LaSalle County Station, Units 1 and 2  
Facility Operating License Nos. NPF-11 and NPF-18  
NRC Docket Nos. 50-373 and 50-374

Subject: Response to Request for Additional Information  
License Amendment Request for Power Uprate Operation

**Attachment**  
**Response to Request for Additional Information**

FIGURE 8a-1: Maximum Normal Heat Load: SFP Temperature Versus Days After Shutdown

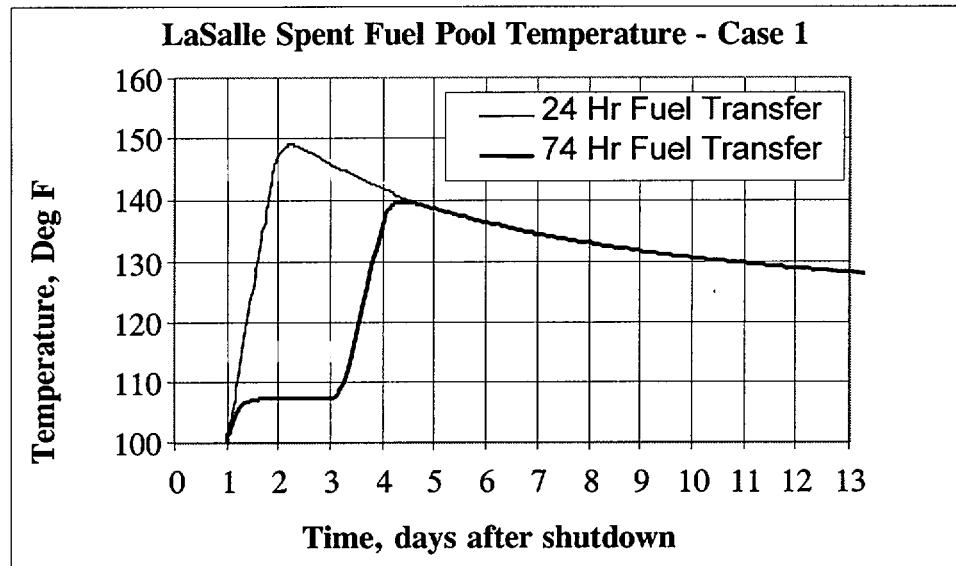
Provide the heat loads and corresponding peak calculated spent fuel pool (SFP) temperatures during planned refueling outages<sup>1</sup> and unplanned full core off-load.

In order to maintain the peak SFP temperature at or below the SRP criterion of 140°F, iterative calculations were performed for various "in-reactor" hold times. If the offload of fuel is delayed until 74 hours after reactor shutdown, the SFP temperature will peak at 140°F at 105 hours (about 4.5 days) after reactor shutdown, then decay. See Figure 8a-1

below. (Note that, because of the initial assumptions of 100°F SFP water in conjunction with 100°F Service Water, the SFP temperature rises slightly prior to the offload, due to the residual decay heat in the pool from the previous pool inventory of SFAs). The UFSAR will be revised, as a result of these power uprate analyses, to require refueling-specific analyses under the current plant conditions to be conducted prior to offload, to ensure that the 140°F criterion is not exceeded during an offload commencing within 24 to 74 hours after shutdown. Also, see the Response to NRC Question 10.

**Figure 11-1: Decay Heat Curve Comparison Between ANS 5.1-1979 and ASB 9-2**

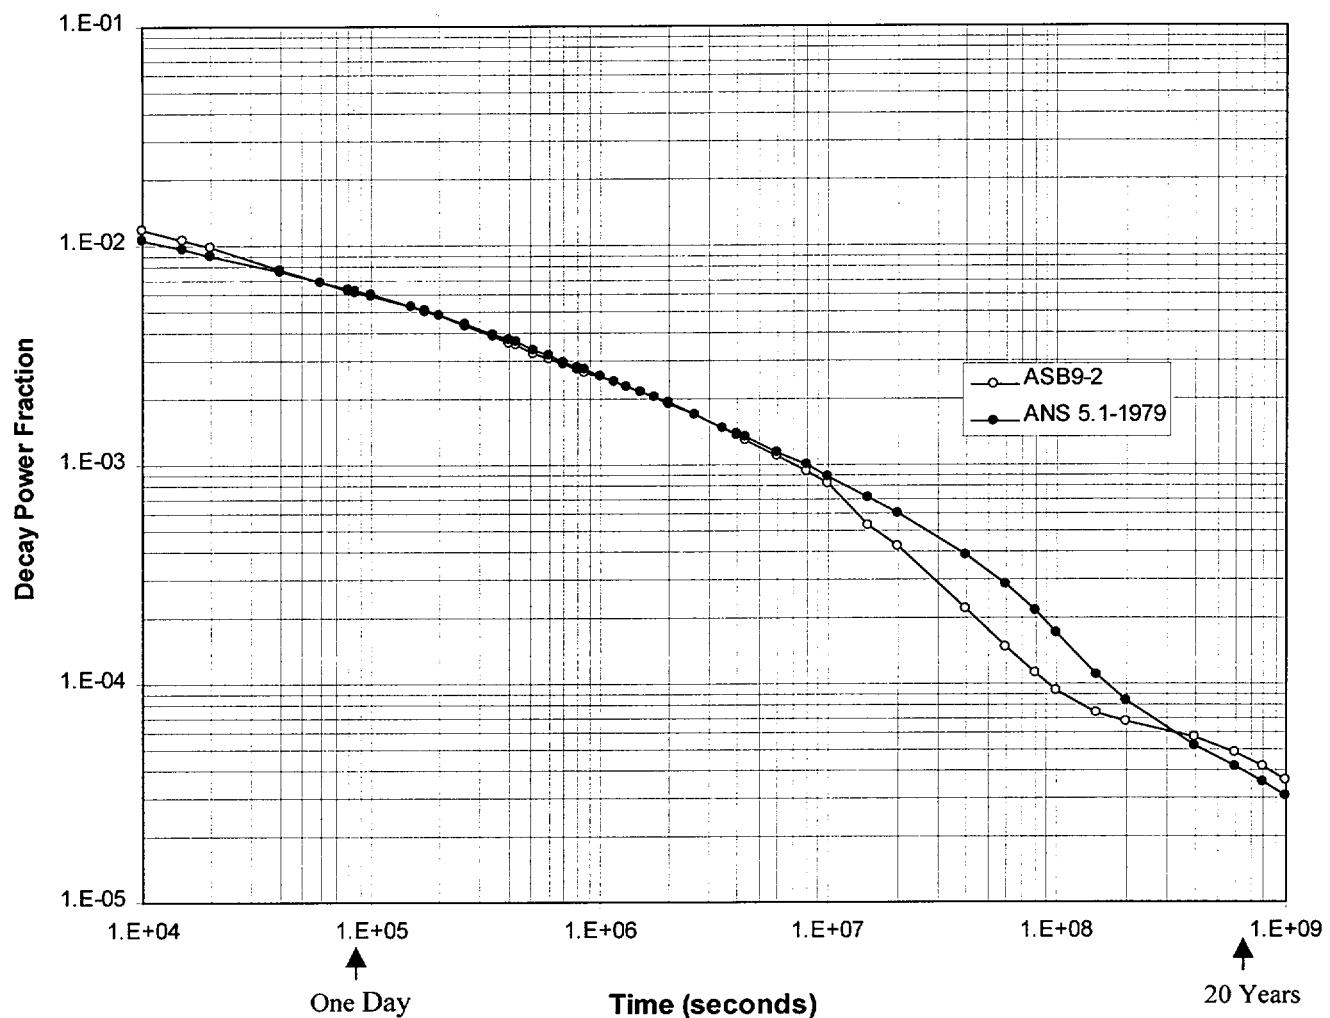
With regard to the SFP cooling, is the Branch Technical Position ASB 9-2, "Residual Decay Energy for Light Water Reactors for Long-Term Cooling" used to perform the decay heat calculations? If not, identify and provide the basis for any deviations and exceptions to the guidance described in Section 9.1.3 of the Standard Review Plan (SRP, NUREG-0800) including the Branch Technical Position ASB 9-2. Also, discuss the assumptions used to calculate the decay heat.

The GE power uprate evaluation is based on the ANSI/ANS-5.1-1979 decay heat standard, with the addition of two sigma uncertainty. This Standard was derived from a combination of experimental data and calculations. These power fractions are shown (Figure 11-1) to be representative of the curves presented in the NRC Branch Technical Position (BTP) ASB 9-2.

The NRC Standard Review Plan 9.1.3 recommends using the decay heat presented in the NRC Branch Technical Position, ASB 9-2. The decay heat curve used for these evaluations, ANS 5.1-1979 Standard with two sigma, is compared to the decay heat curve in ASB 9-2, in Figure 11-1. The decay curve shown in ASB 9-2 uses lower exposure than this GENE application, and therefore the ASB 9-2 decay curve was adjusted (increased) to match the exposure used in this application. Throughout the entire application range of 1 day to 20 years (8.64 E4 seconds to 6.3 E8 seconds), the ANS 5.1-1979 standard with two sigma has a higher decay heat ratio than the ASB 9-2 curve except for the following ranges:

Overall comparison of the two decay heat standards shows that the decay heat calculated by the ANS 5.1-1979 Standard is higher than that calculated by the ASB 9-2 curve for the SFP temperature calculations for LaSalle. This is true for both the heat loads resulting from the fuel discharged for Cases 1, 2, and 2a and for the heat loads from the previous cycles. Therefore, it is conservative to use the ANS 5.1-1979 Standard instead of the ASB 9-2 decay curve.
